# **A1 in Northumberland: Morpeth to Ellingham**

**Scheme Number: TR010059**

## **Summary of Proposed Changes to Application**

<b>Regulation Reference:</b>	Infrastructure Planning (Examination Procedure) Rules 2010
<b>Planning Inspectorate Scheme Reference</b>	TR010059
<b>Document Reference</b>	TR010059/7.5
<b>Author:</b>	A1 in Northumberland: Morpeth to Ellingham Project Team, Highways England

1.5

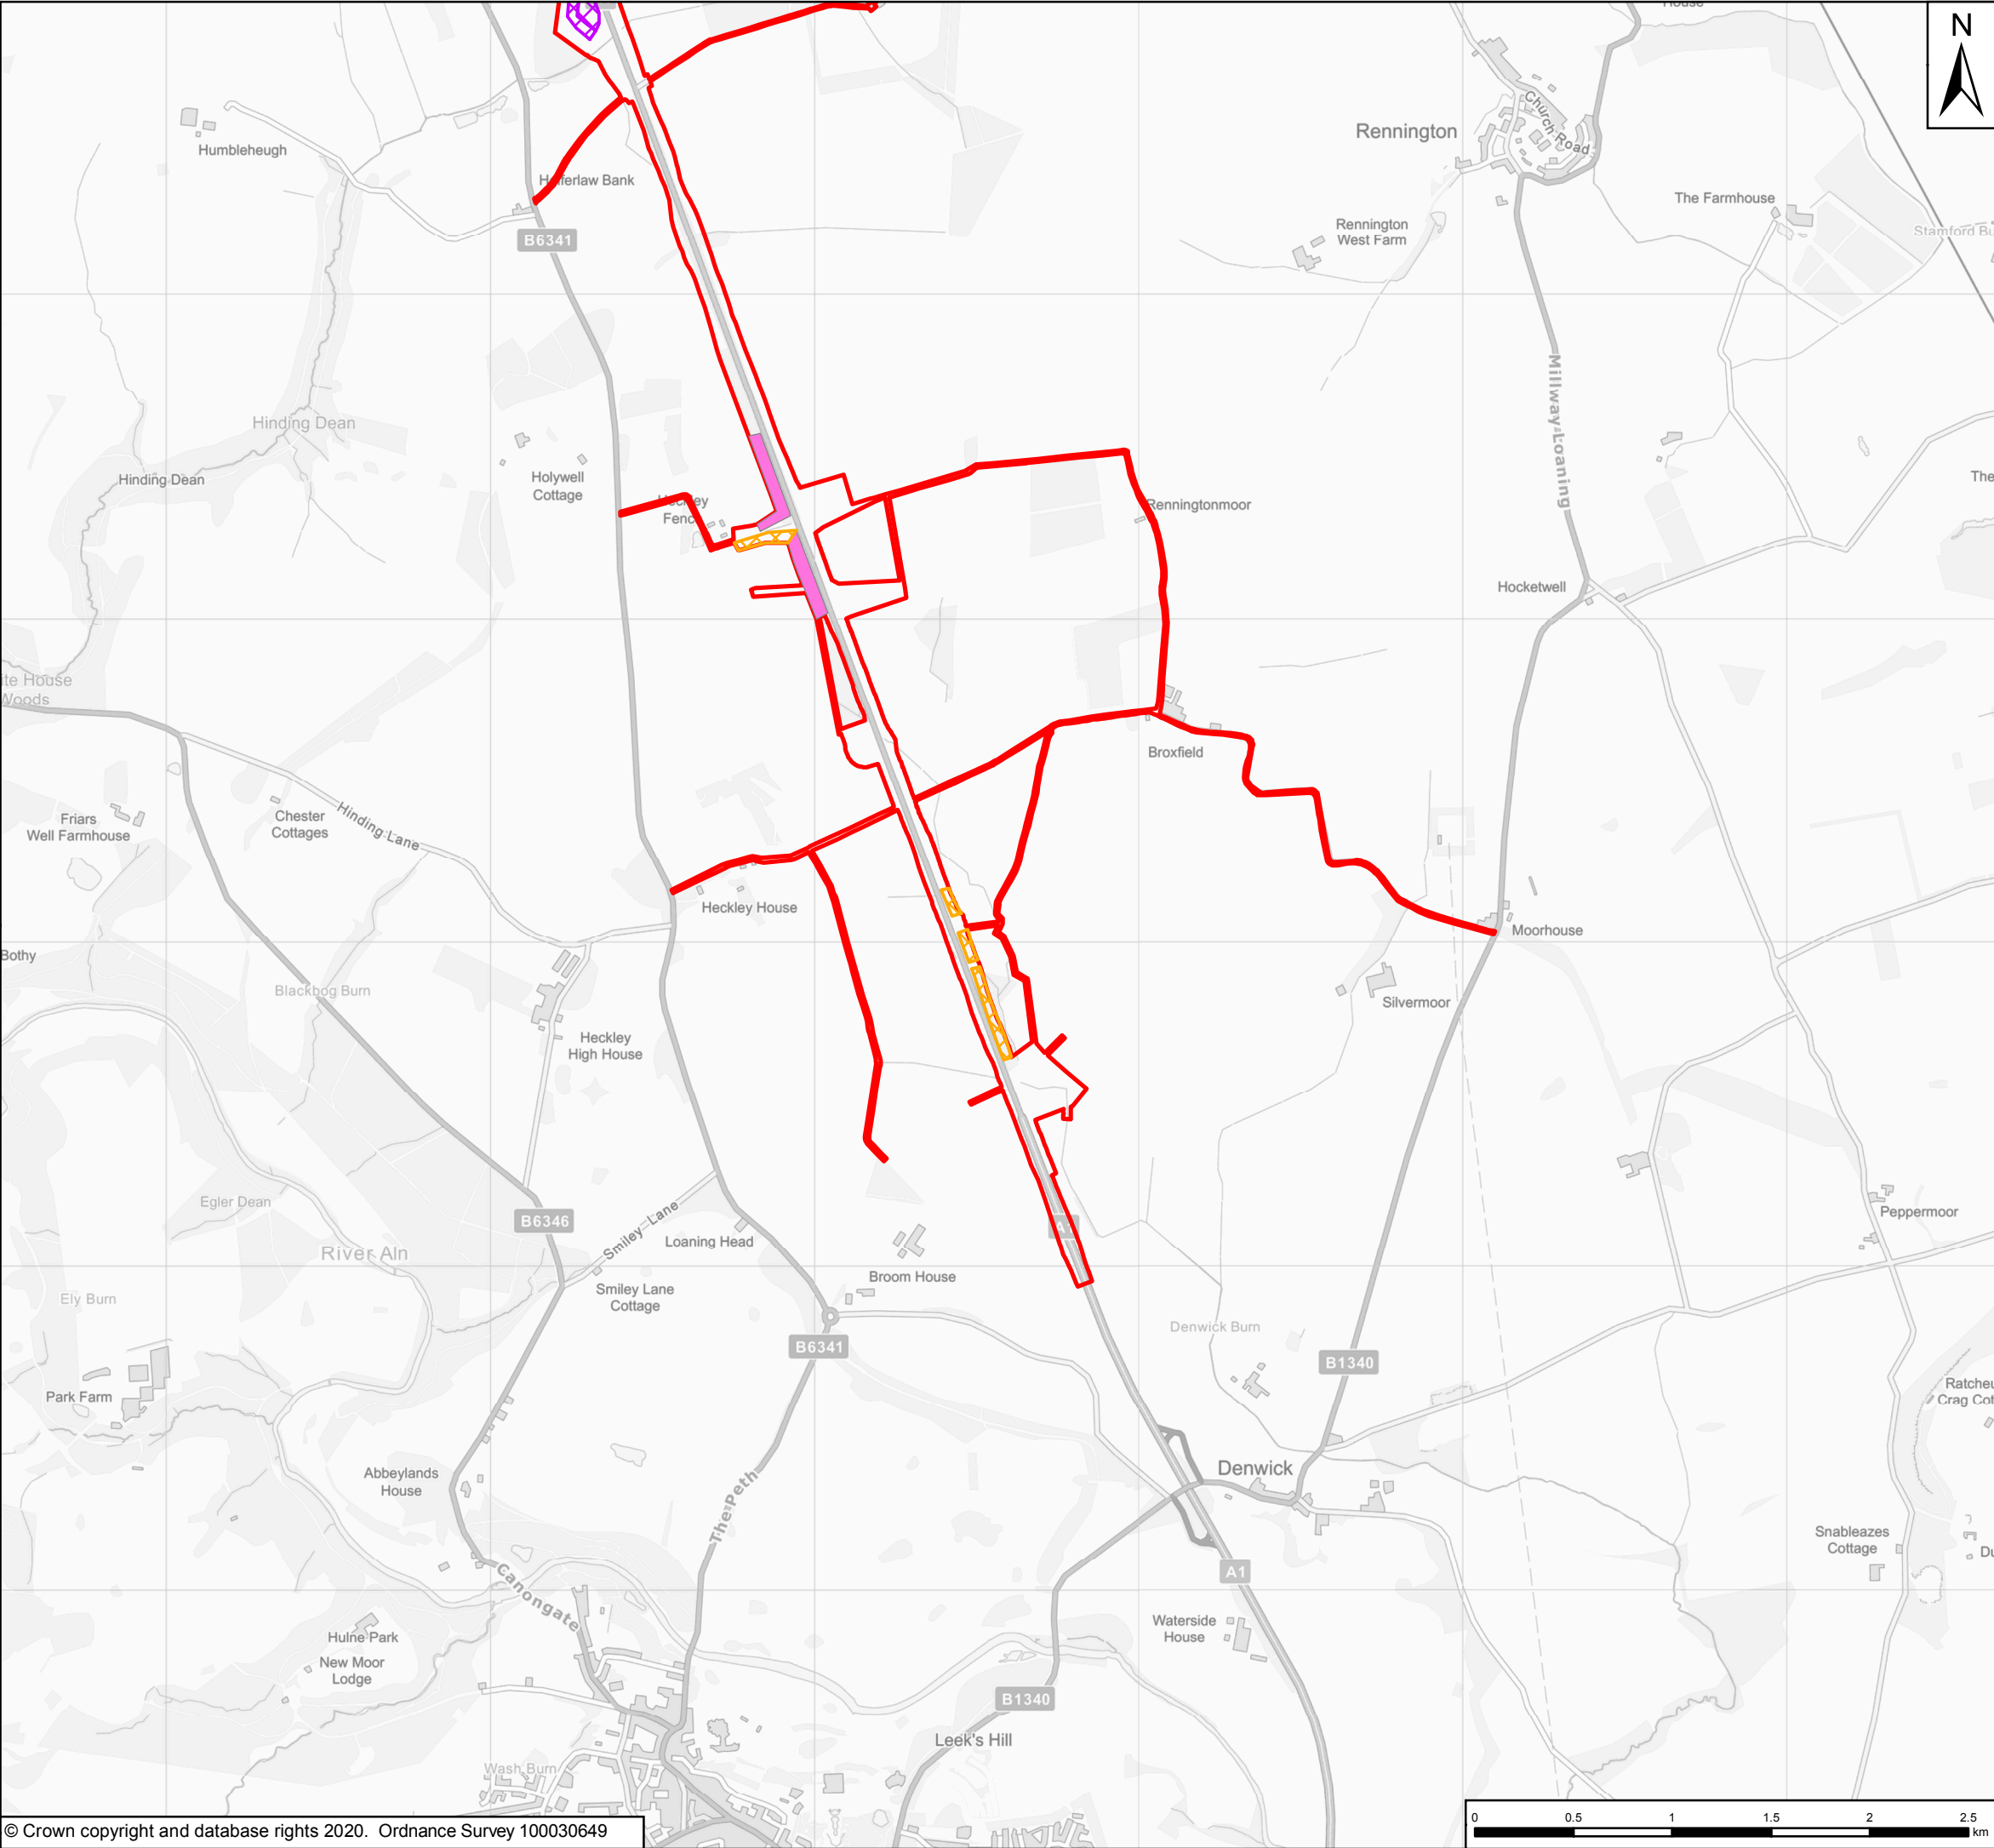
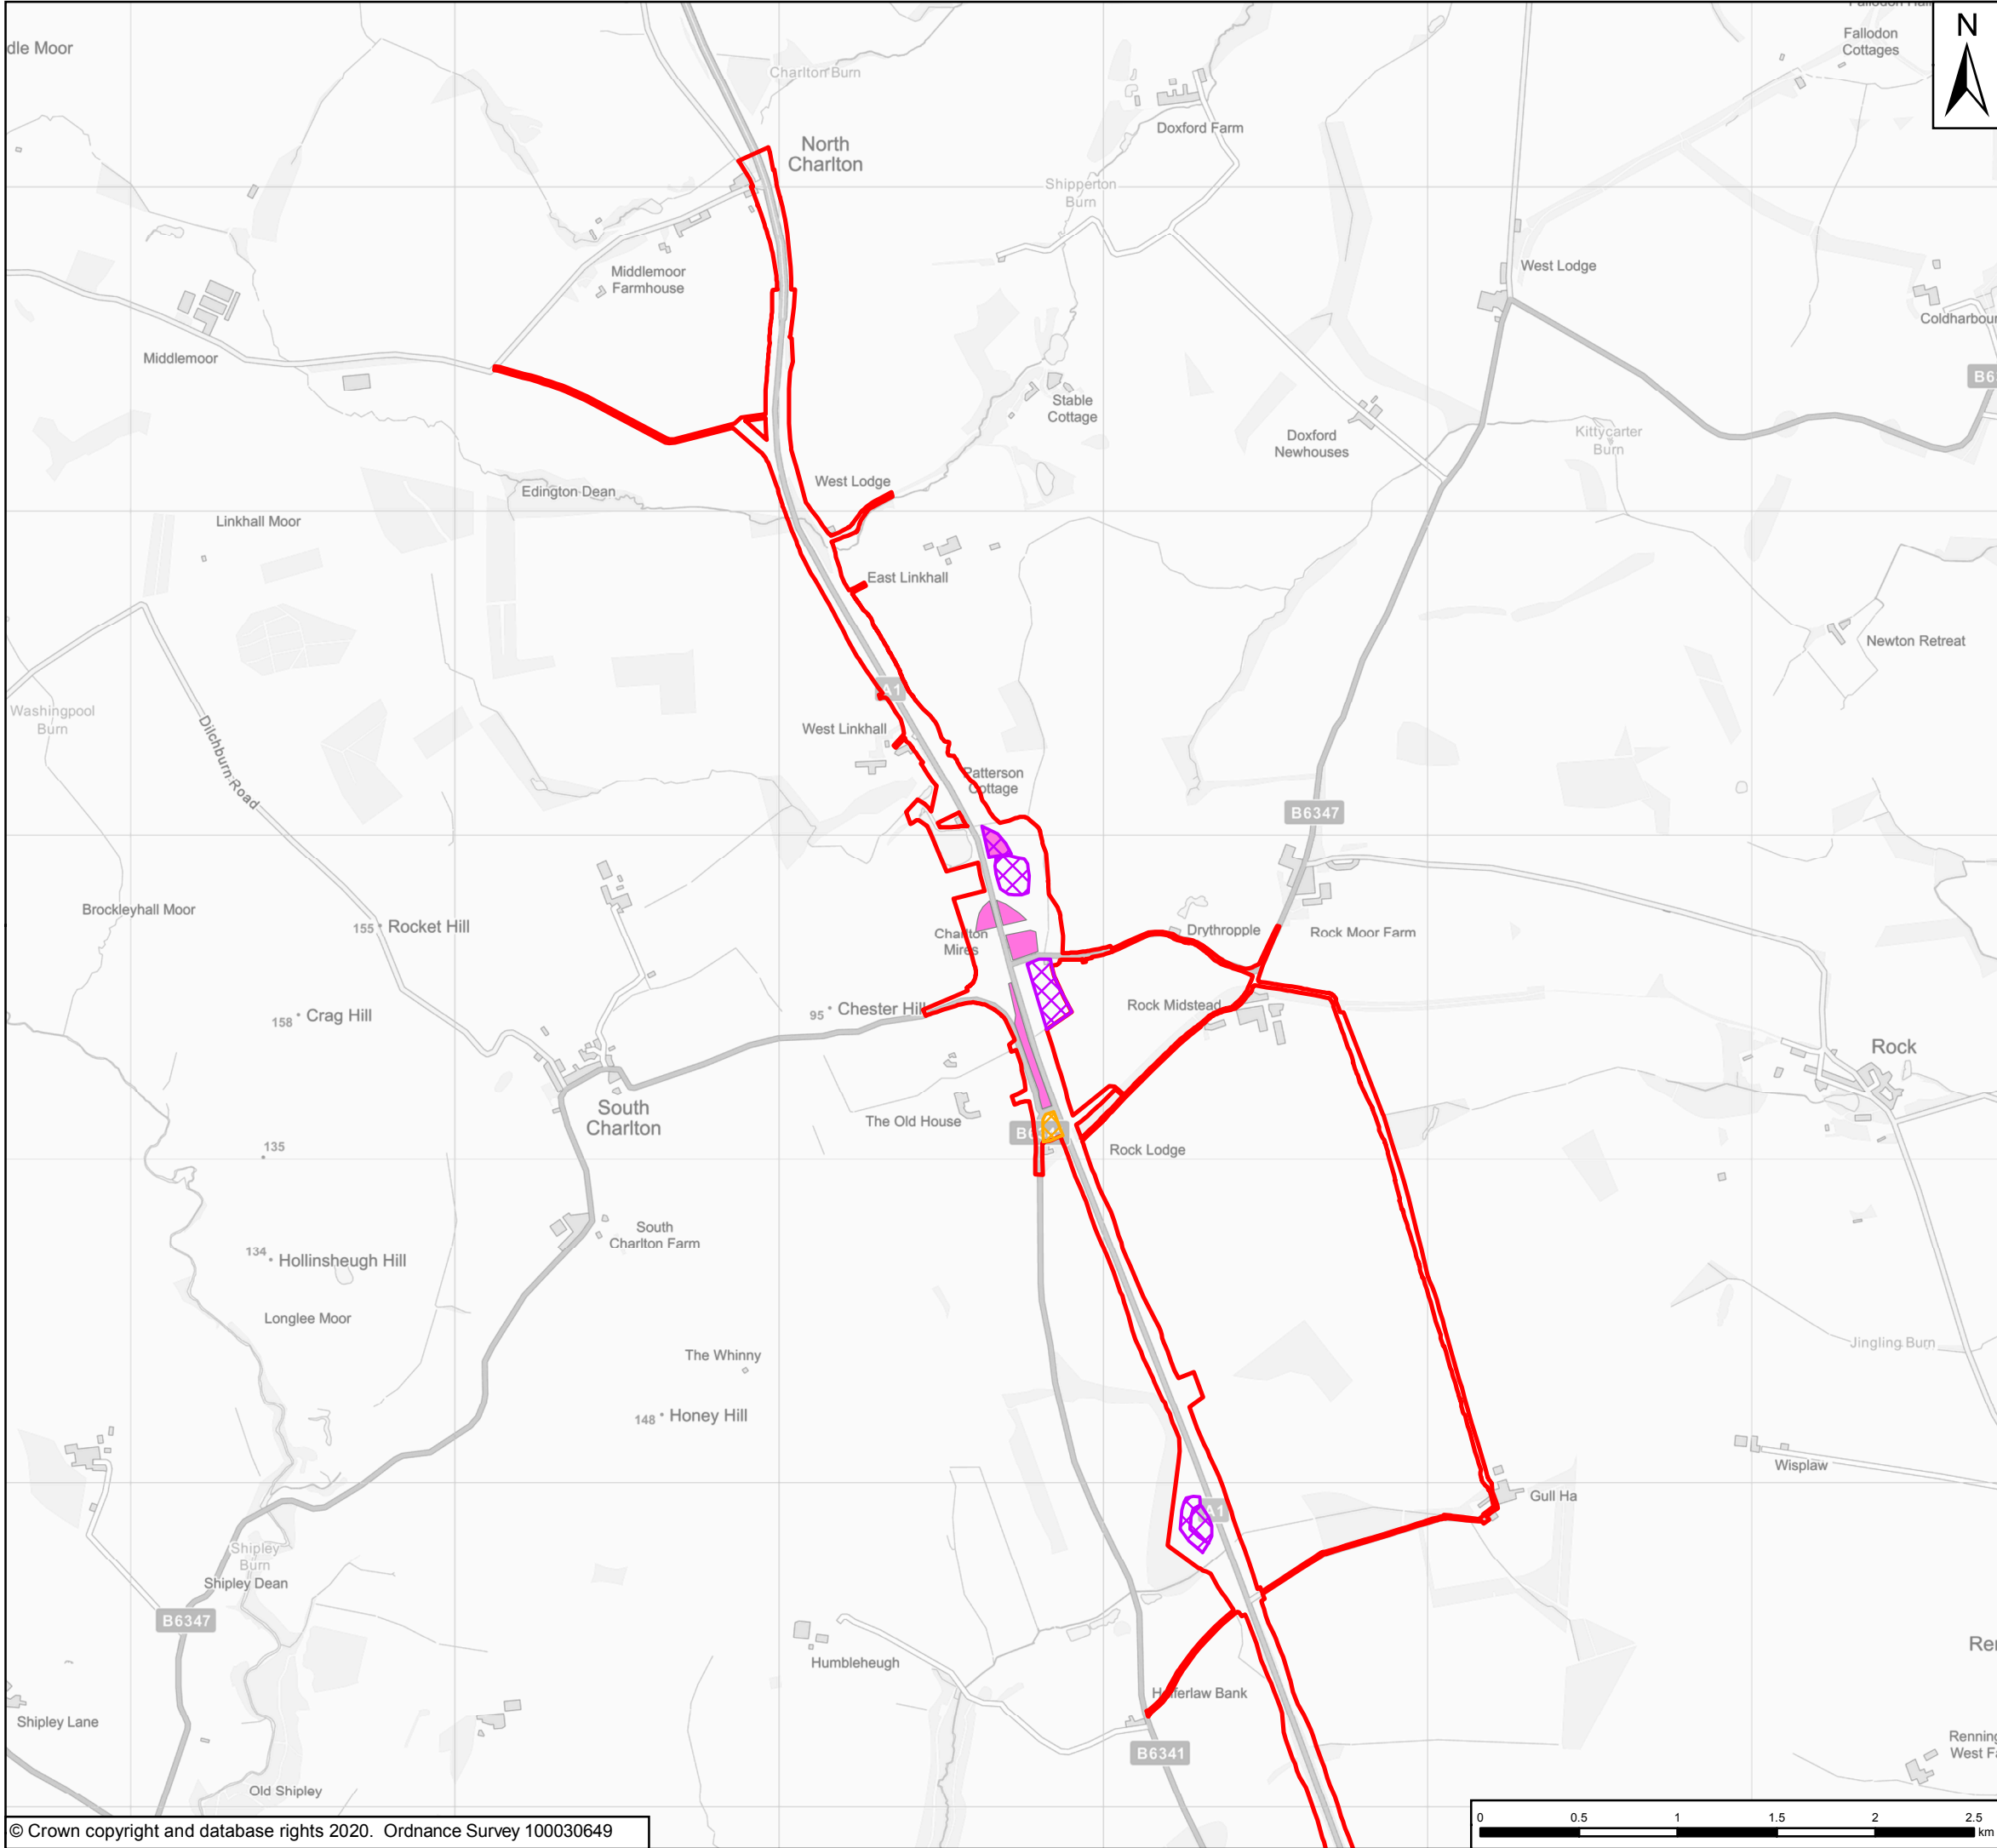
- 2.1.1 The Applicant proposes to maximise the re-use of materials (via excavation, deposition and temporary storage), within the existing Scheme extents. A recent review of the earthworks strategy has identified an opportunity to reduce earthwork movement and as a result greater flexibility in temporary and permanent storage of Site won material is required to achieve this. The indicative earthworks areas are shown in the figure in the **Indicative Earthwork Change Locations** figure in **Appendix A**.

## Temporary Works at the River Coquet

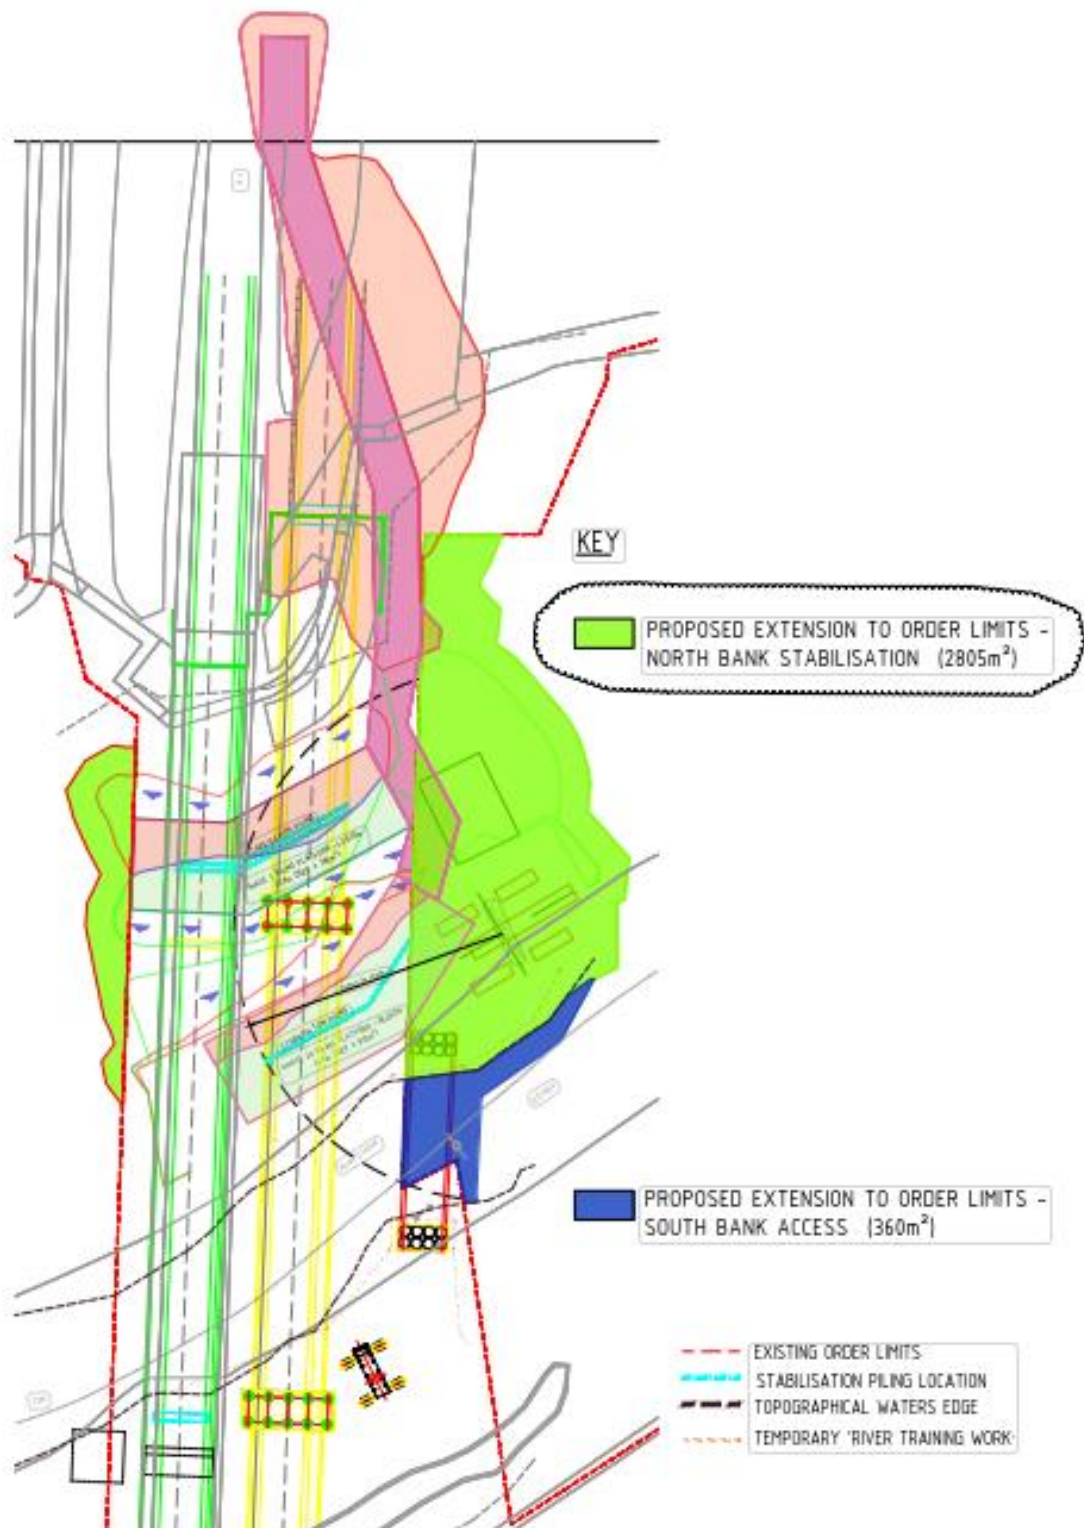
- 2.2.6 Should the erosion protection measures only be installed along the riverside within the current Order limits, it is highly likely that further significant engineering interventions and erosion protection measures would be required in the future in order to protect the new bridge foundations from undermining and slope instability. Therefore, in order to provide robust erosion protection and prevent a deterioration of the toe of the slope of the North bank of the River Coquet over time, it is proposed that rights are acquired for installation and retention of scour protection in additional land that extends beyond the current Order limits, the extent of this additional land is shown in the **Temporary Works at the River Coquet** in **Appendix A**.

- 2.3.2 The works described in **Section 2.2** of this document include the construction of a temporary haul road which extends to the north riverbank. A temporary working area is already proposed on the south bank adjacent to the southern pier. It is proposed to include a temporary bridge to provide an access between these two working areas. A small area of additional temporary working area across the river will be required to provide this crossing, as shown in the **Temporary Works at the River Coquet** figure in **Appendix A**.
